CITY OF SAN ANTONIO
CAPITAL IMPROVEMENTS MANAGEMENT SERVICES DEPARTMENT

PROJECT NAME: Callaghan Road – Culebra to Commerce
PROJECT NO. 40-00007

DATE December 13, 2010

ADDENDUM NO. 2

MAP No. 126-584
SECT. No.
DR.GP&NC CK. ETM JOB No. 08-5558
SHEET 8 OF 9

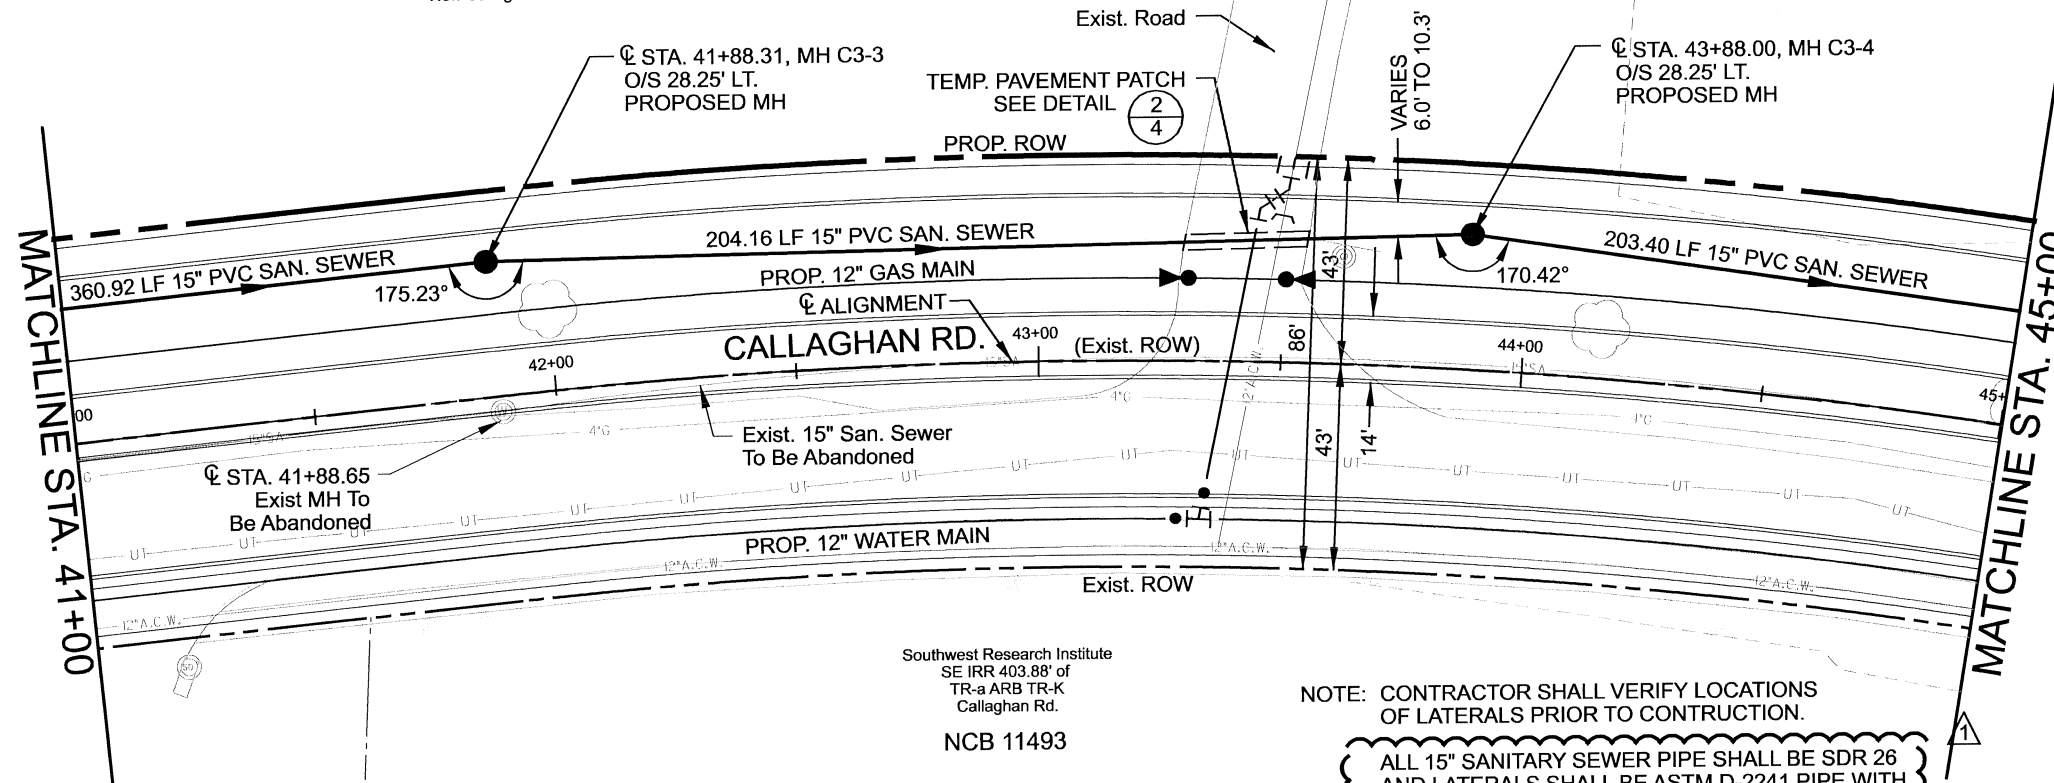
ITEM NO. 6: Sanitary Sewer sheets 7, 8 & 9 have been revised. A note has been changed to read "ALL 15 " SANITARY SEWER PIPE SHALL BE SDR 26 AND ALL LATERALS SHALL BE ASTM 2241 PIPE WITH A MINIMUM PRESSURE RATING OF 160 PSI". Sheets attached.

ALL 15" SANITARY SEWER PIPE SHALL BE SDR 26 AND LATERALS SHALL BE ASTM D-2241 PIPE WITH A MINIMUM PRESSURE RATING OF 160 PSI.
